Request of Class II Permissive Change

FCC ID: APIJBLXTREME3N

This is to request a Class II Permissive Change for FCC ID: APIJBLXTREME3N originally granted on 08/20/2020, due to battery cell added.

Original:
Battery:

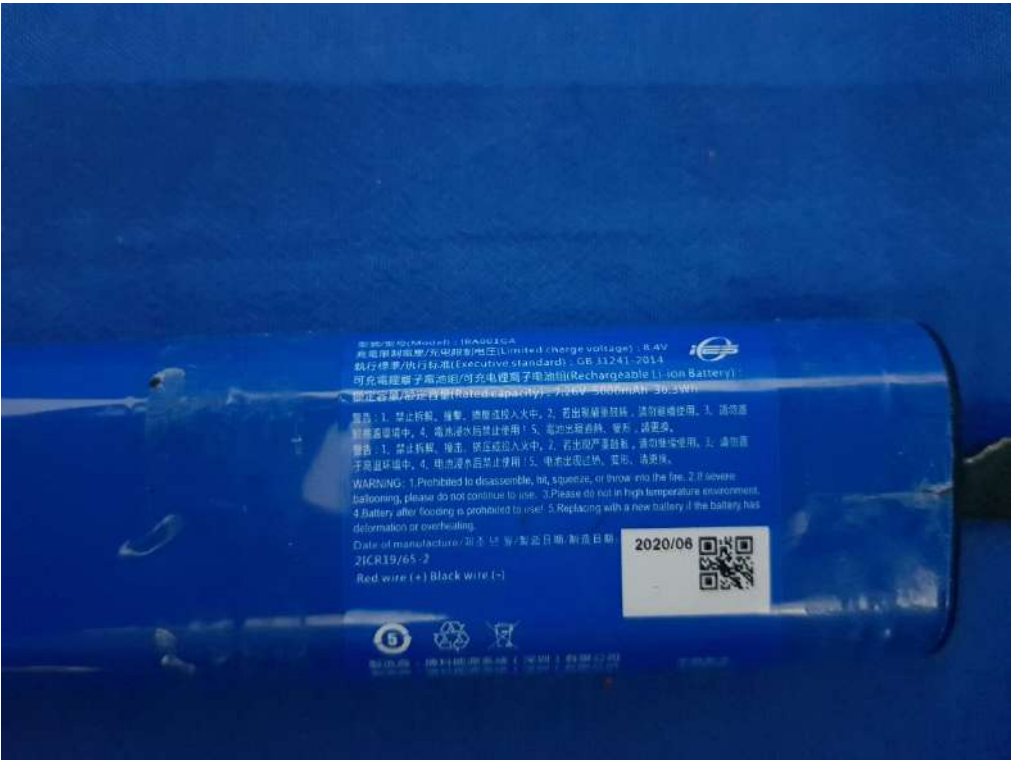
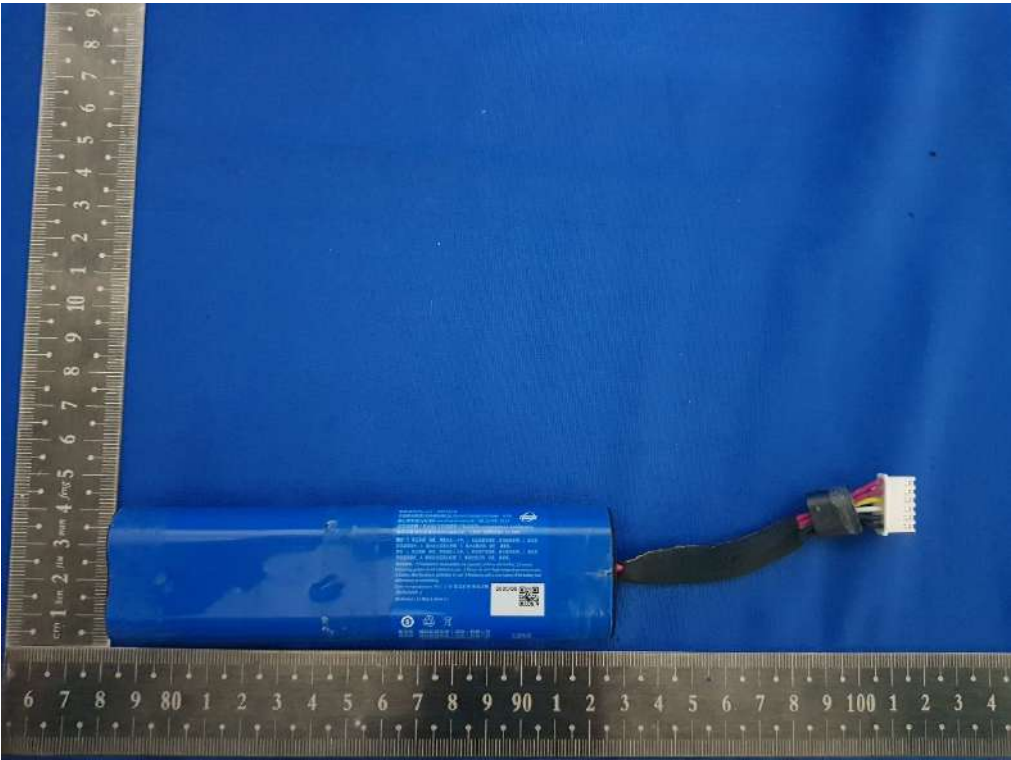
Battery		Manufacture	Model	Description
	Original	ICON ENERGY SYSTEM (SHEN ZHEN) CO., LTD.	IBA001GA	Rated Capacity: 7.26V 5000mAh 36.3Wh; (TI IC BQ28Z610)
	New	ICON ENERGY SYSTEM (SHEN ZHEN) CO., LTD.	IBA001GA	Rated Capacity: 7.26V 5000mAh 36.3Wh; (TI IC BQ27750)

The newly added battery cell will affect the performance of AC power-line conducted emissions and radiated emission (below 1 GHz), and C2PC applied for this.

New Battery IC: TI IC BQ27750
